Delegated Report

Householder Planning Application

Planning Application No: 20231090

Location: 102 St Hildas Way Gravesend Kent DA12 4AY

Google Street View May 2018

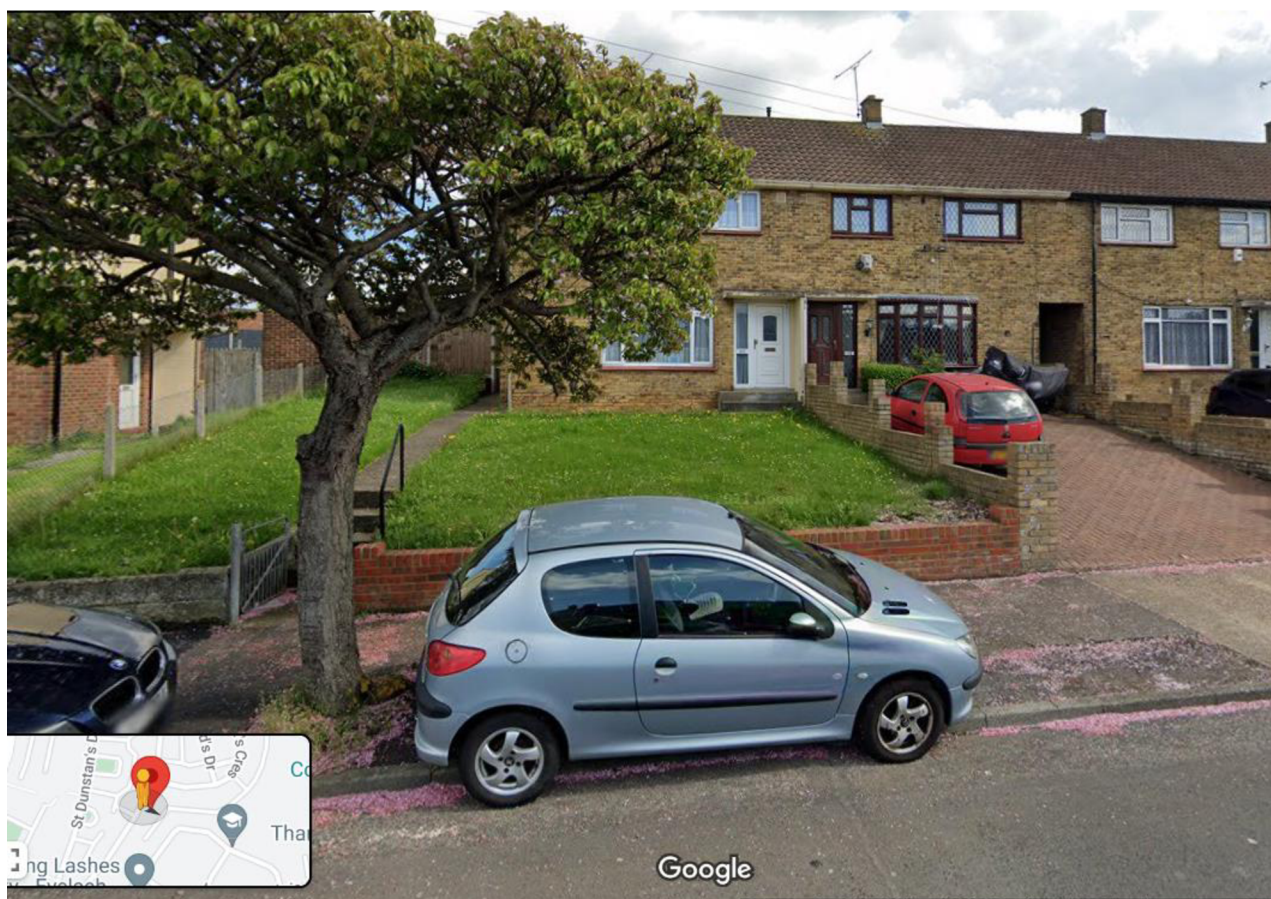
I have concerns on the ability to park in the front garden so a parking plan conforming to the requirements of Kent County Council SPG4 should be presented. Also, with the extra bedroom a cycle parking space should be provided to comply with the same guidance.

Kent County Council will not agree to the removal of street trees to facilitate an access.

The applicant therefore should establish the carriage crossover and an approved parking layout before either the application is approved or alternatively before construction commences.

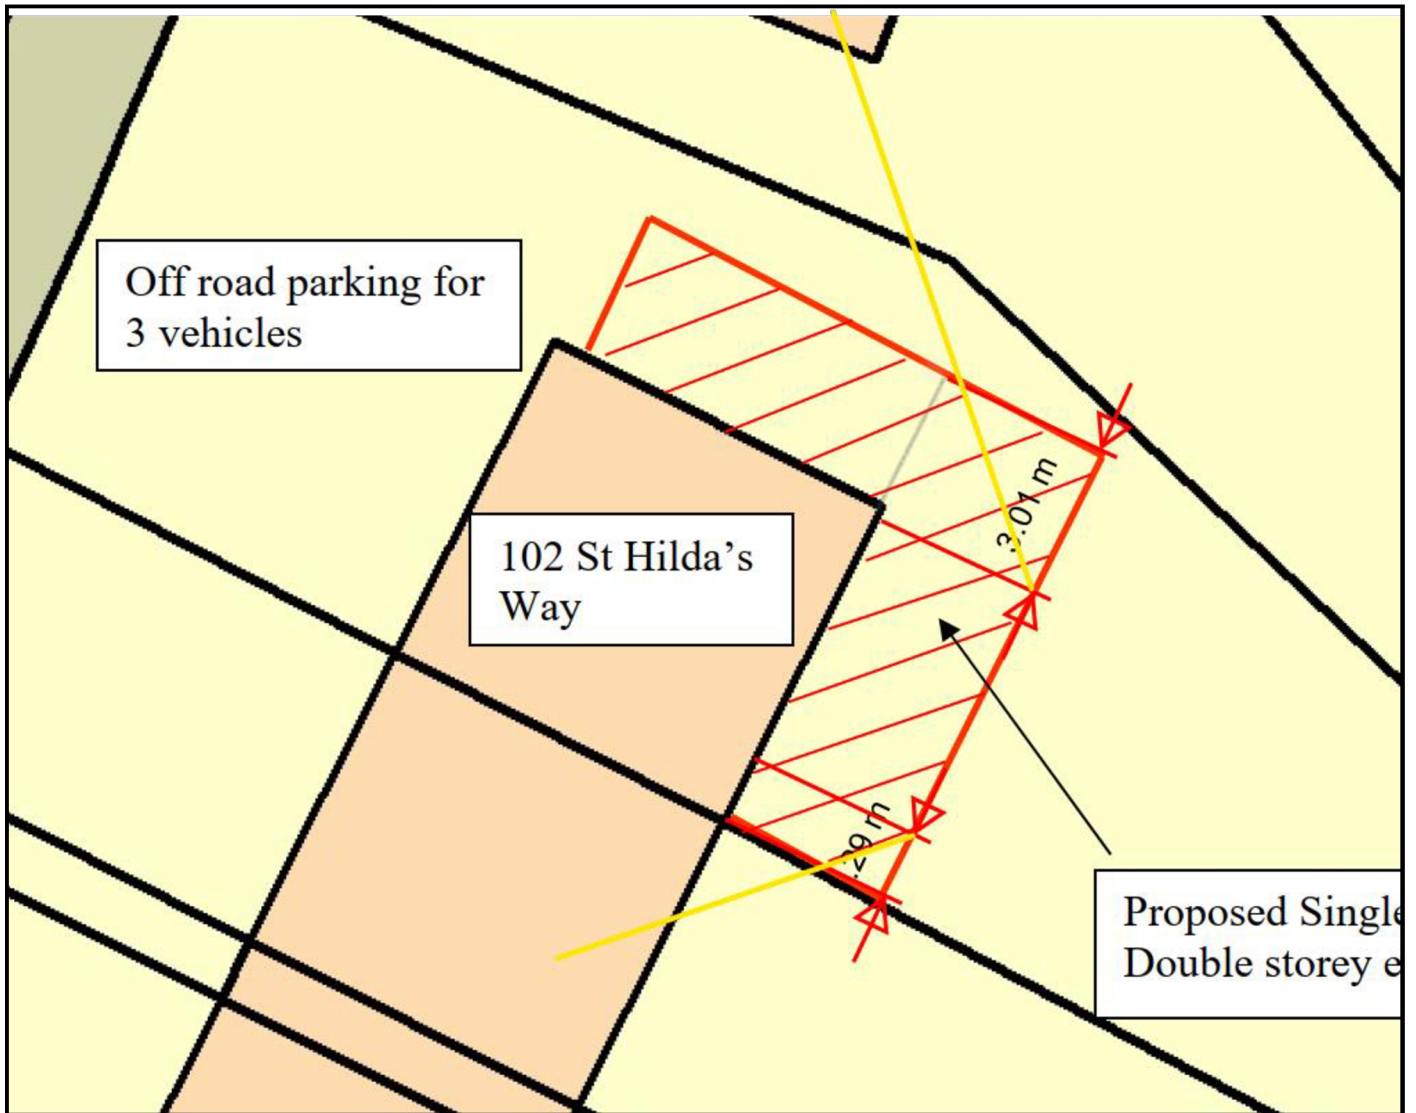
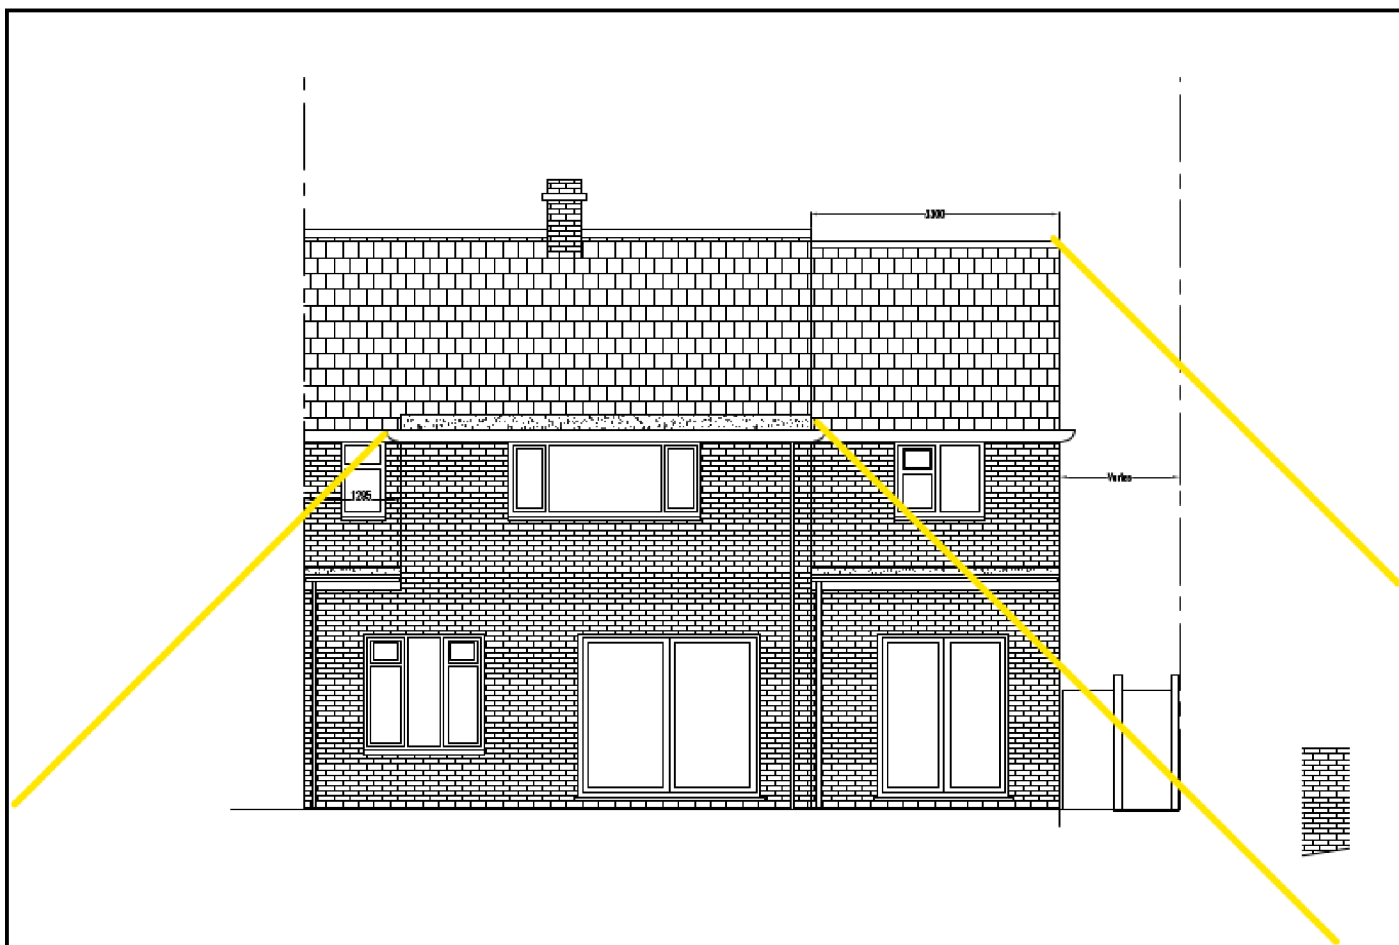
The below images show a 45-degree test taken from two storey elements of the proposal. As can be seen the ground floor window to the side elevation of 104 Sy Hildas Way could potential be overshadowed. However, given the distance of 4.4m which would be maintained between the buildings, it would be unlikely to result in significant overshadowing of this neighbour.
